**WASTEWATER STUDY
JAYNES PROPERTY – PRELIMINARY PLAN
POCO ROAD AND VOLLMER ROAD
EL PASO COUNTY, COLORADO**

Prepared for:
**Elite Properties of America, LLC
2138 Flying Horse Club Drive
Colorado Springs, CO 80921**

November 21, 2023

JOB NO.
212381
FIG. 8

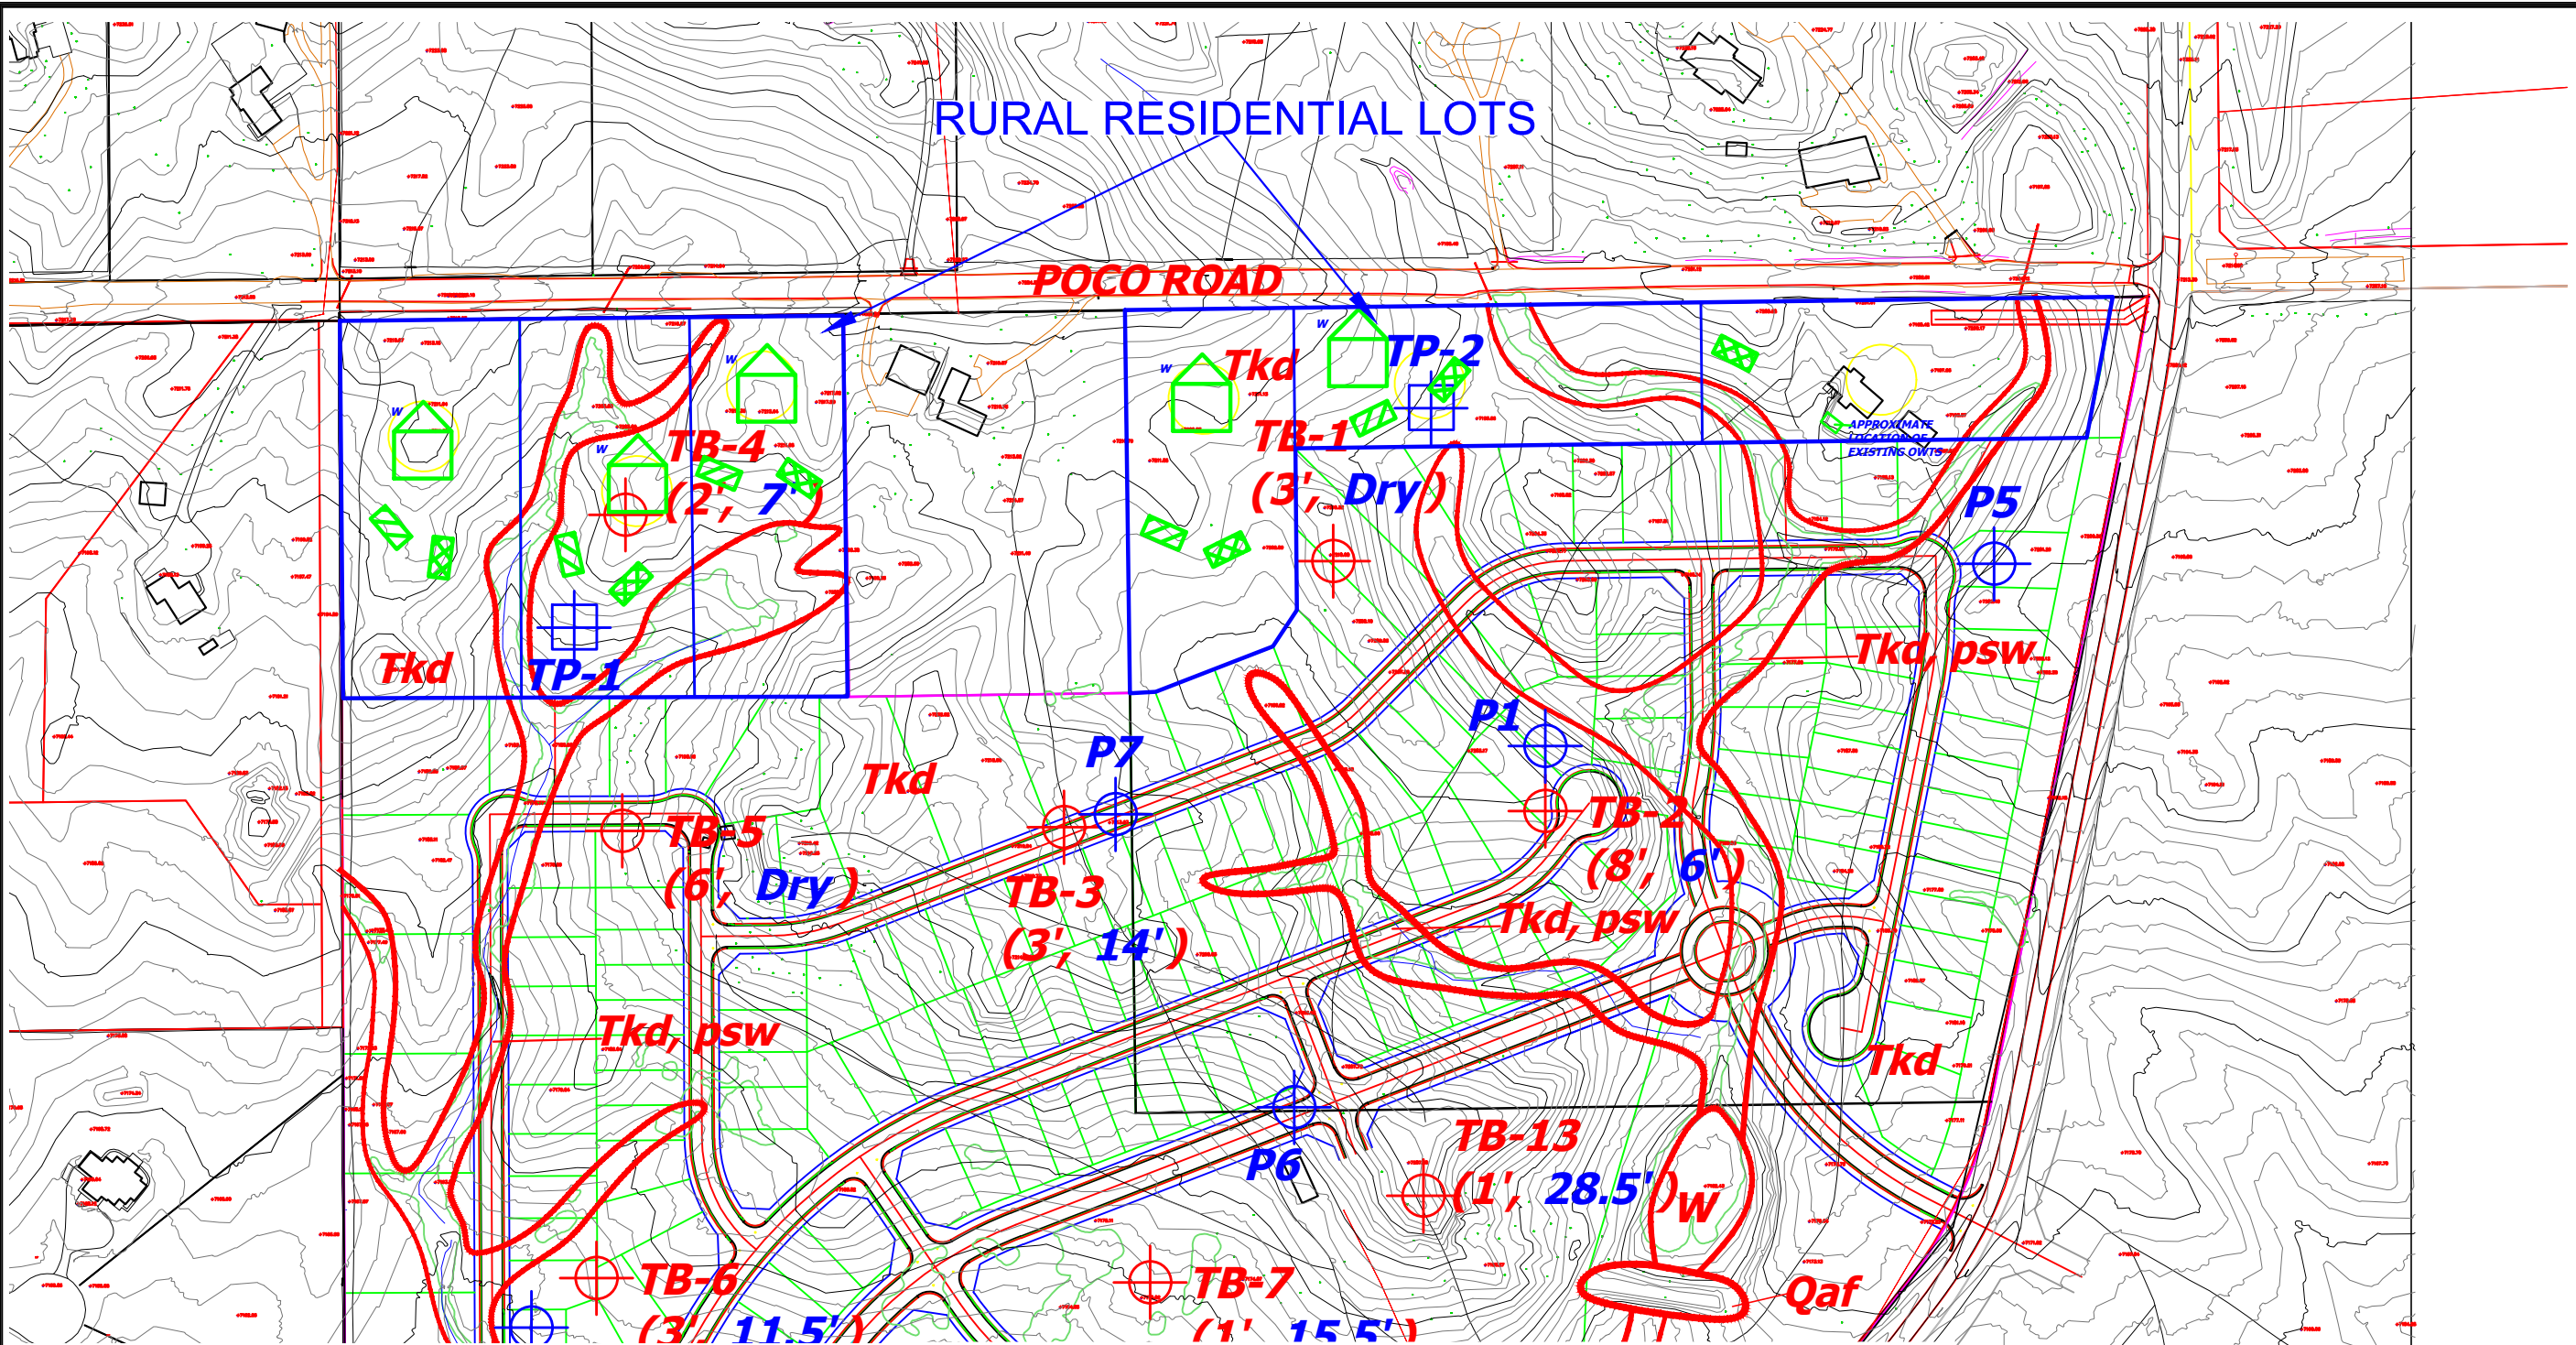
this does not include requirements for central system report in Chapter 8.4.8; not map the 2 suitable septic sites for rural lots per Section 8.4.7. Please review Code and update
